No. RDSO-TILKO(OHE)/33/2020 (Part-2)

विषय/Sub: SMI No. TI/MI/0056 Rev. 2 on "prevention of monkey menace"
(MSG Item 30.20)

1. TITLE: Prevention from climbing of Monkey over Traction Installation structures.
2. OBJECTIVE: To minimize the failures of **Traction Installations (OHE, SP/SSP/FP/TSS)** due to climbing of the monkey over High Voltage live structures **(Mast, Portal upright, Gantry Mast upright etc.)** causing Electrical and Mechanical failures resulting in traffic disruption, loss of material and man hours.

Annexure-II

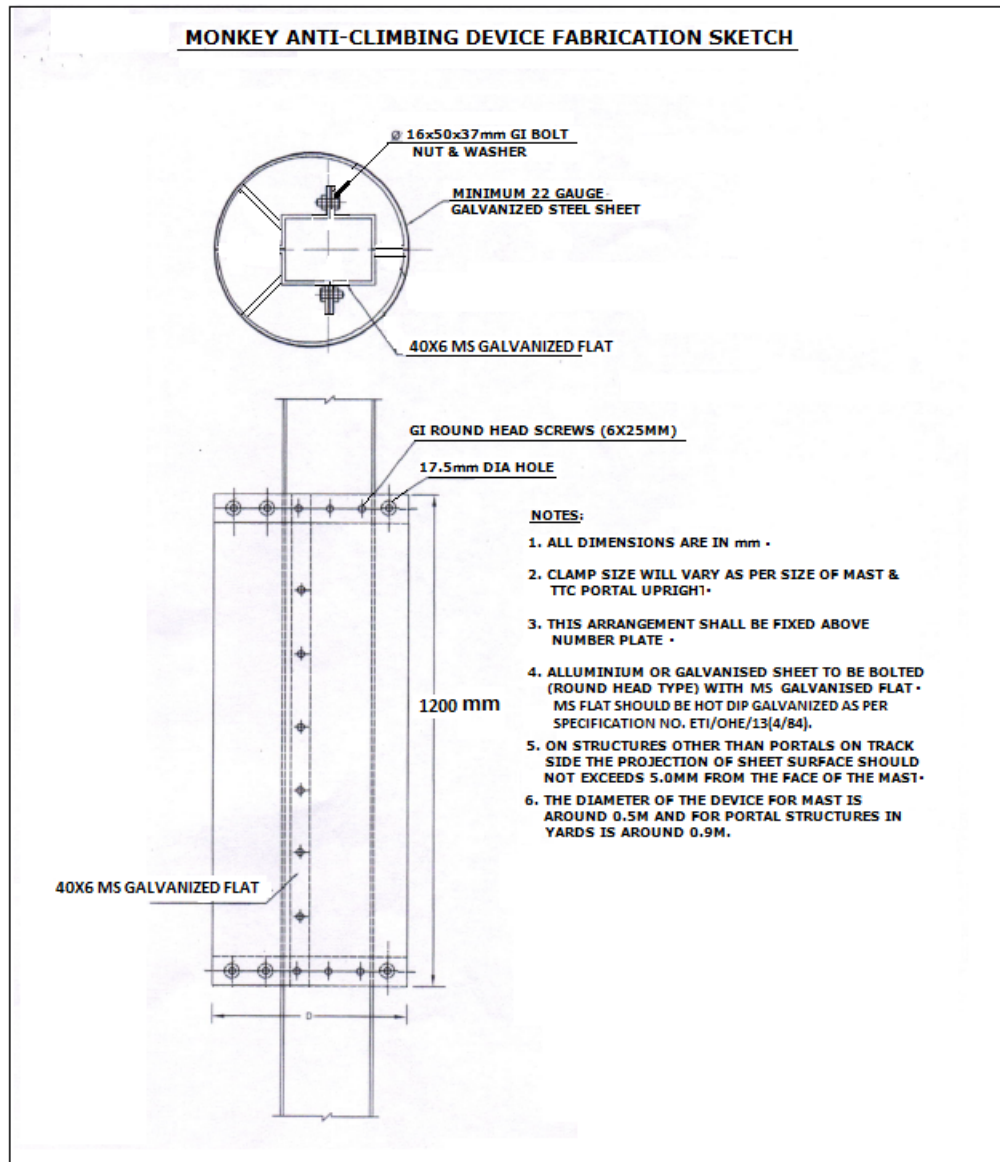
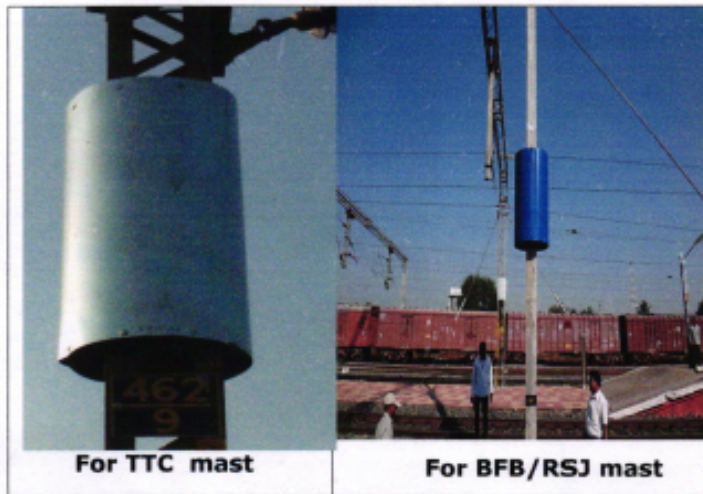
2. Standard barbed wire frame arrangement as per Drg. No. TI/SK/OHE/ANTIMON/ RDSO/ 00001/08/0 (advised vide this office letter no. TI/OHE/INS/GEN/08 dated 03.11.2008) and cylindrical drum arrangement was given in SMI No. TI/MI/0056 Rev.1. The length of the cylindrical drum was specified as 1 meter. Material for Fabrication of Cage was 40X6 Galvanised Flat.

3. As per the decision of 31st MSG meeting circulated vide reference (ii) above, RDSO to review the SMI for length of drum to 1.2m and change in material for fabrication of cage as MS Galvanized Flat.

4. In compliance to Railway Board decision of 31st MSG Meeting, the Cylindrical Drum arrangement has been modified as proposed by Central Railway and revised SMI No. TI/MI/0056 Rev.2 on "Prevention from climbing of Monkey over Traction Installation Structures" is enclosed herewith for implementation.

- 3.1.1 Barbed wire frame Arrangement: Annexure-I- Latest revision of Drg. No. TI/SK/OHE /ANTIMON/RDSO/ 00001/08/0.
 - 3.1.2 Cylindrical Arrangement:
 - 3.1.2.1 Annexure-II-drawing. Galvanized Steel or Aluminum Cylindrical Drum.
